June 20, 1997
OG-1661

Subject: B&WOG Generic License Renewal Program Topical Report BAW-2251,
"Demonstration of the Management of Aging Effects for the Reactor Vessel"
(Responses to RAI #18 and 19)

Reference: Letter from P. T. Kuo to David J. Firth, dated April 2, 1997; Subject: Request for
Additional Information in the Case of BAW-2251, "Demonstration of Aging
Effects for the Reactor Vessel," (RAI Nos. 18 through 26)

Figure 1. KI vs. Crack Tip Temperature for HL-LOCA

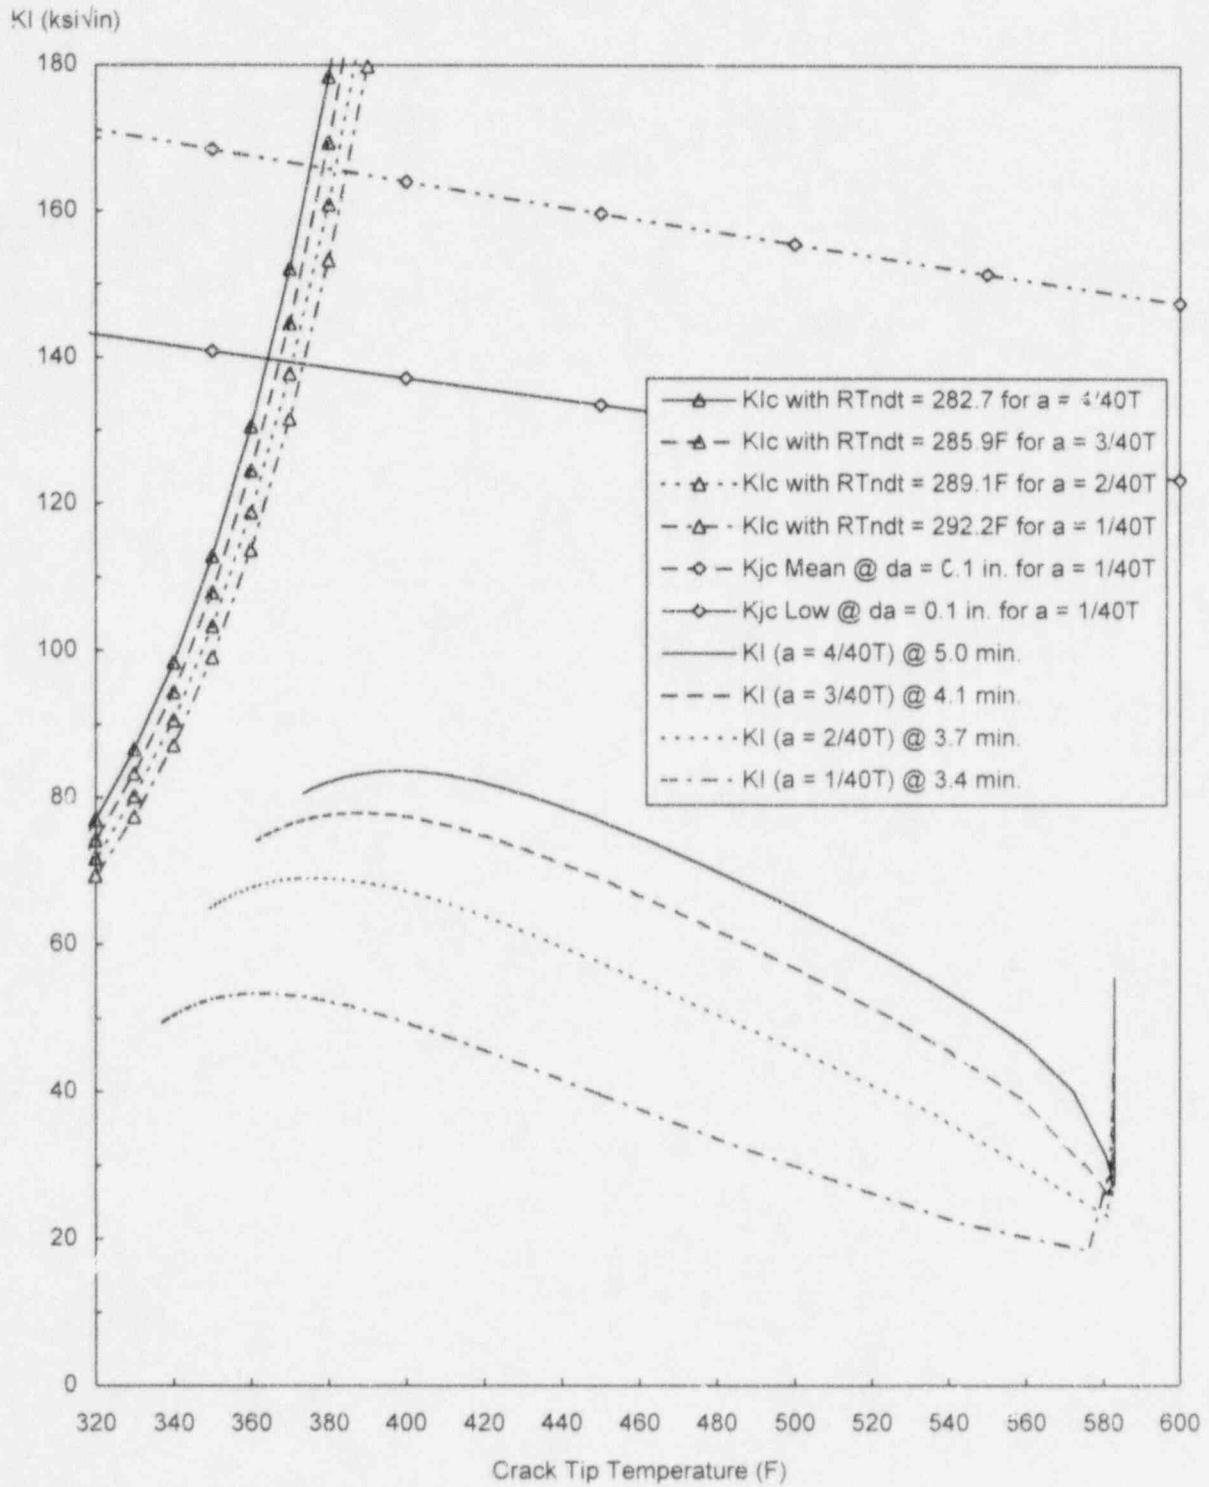
19.	<p>Page 6-1, 6.2 Limiting Level C and D Service Loading—For Level C and D conditions, meeting the acceptance criteria of Appendix K has not been demonstrated for cracks with a depth less than one tenth of the wall thickness (1/10T). Provide a quantitative analysis to demonstrate that the analysis on a crack depth of 1/10T flaw depth is bounding.</p>	<p>Appendix K states the analysis for Level C and D service conditions shall consider flaw depths up to one-tenth of the base metal wall thickness. By demonstrating that the Level C and D service loads decrease with decreasing flaw size, it can be shown that analysis based on a 1/10T flaw depth is bounding.</p> <p>From Table 6-1 of BAW-2275, the limiting weld for Level C and D service conditions is SA-1526; and, from Figure 6-5 of BAW-2275, the limiting transient is the Hot Leg Loss of Coolant Accident (HL-LOCA). Figure 6-5 also shows that at the critical time of the transient (5 minutes), the stress intensity factor for a 1/10T flaw is well below the material fracture toughness at a crack tip temperature of 400 °F. A set of curves for the HL-LOCA transient, similar to Figure 6-5, can be constructed to include the original 1/10T flaw depth as well as</p>	Open	No change to the report.

NRC RAI	NRC Comment	GLRP Response	Status	Proposed Revision	Remarks															
		<p>three smaller flaw depths (1/40T, 1/20T, and 3/40T).</p> <p>The PCRT code that was used to compute stress intensity factors for the HL-LOCA was re-run to obtain output at additional flaw depths. Results from this re-analysis are shown in Figure 1 (see attachment to RAI responses). The critical transient times for the various flaw depths (times of maximum stress intensity factor) are:</p>

<p>Figure 1 demonstrates that the bounding flaw depth is 4/40T, or 1/10T. Figure 1 also reveals how the ASME Code fracture toughness curves, K_{Ic}, vary with RT_{NDT}, or indirectly, with flaw depth. It is noted that the upper shelf fracture toughness values, K_{Ic}, derived from the J-Resistance model for Linde 80 material at a flaw extension of 0.1 in., are also a function of flaw depth, based on fluence at the crack tip. However, this is a weak dependence on flaw depth, and only the limiting upper shelf toughness values (for the shallow 1/40T flaw) are plotted.</p>	Flaw Depth	Critical HL-LOCA Time	K (ksi√in)	1/40T	3.4 min.	53.4	2/40T	3.7 min.	69.0	3/40T	4.1 min.	77.8	4/40T	5.0 min.	83.6			
Flaw Depth	Critical HL-LOCA Time	K (ksi√in)																		
1/40T	3.4 min.	53.4																		
2/40T	3.7 min.	69.0																		
3/40T	4.1 min.	77.8																		
4/40T	5.0 min.	83.6
